Illustrated Parts List - IPL Update

572XP/XPG

STARTER

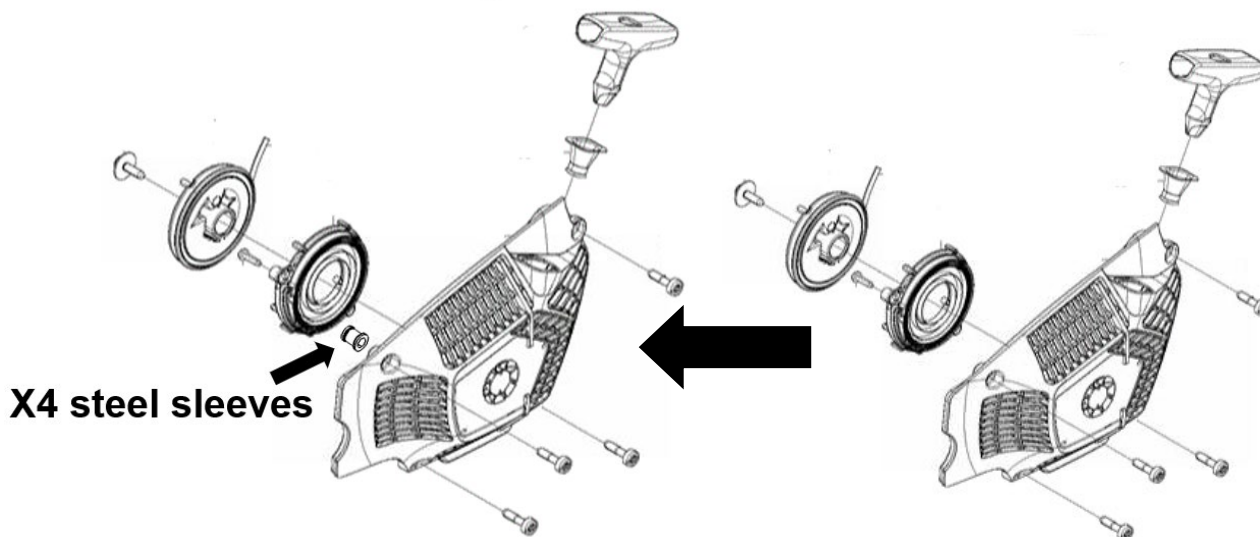
New Starter housing with four steel sleeves added. Increased screw torque to 6Nm (was 4Nm).

Reason: Better fastening of starter housing in crank case.

New article 575 52 76-04 Starter housing assy is fully interchangeable.

New article 575 52 58-02 Starter housing is fully interchangeable.
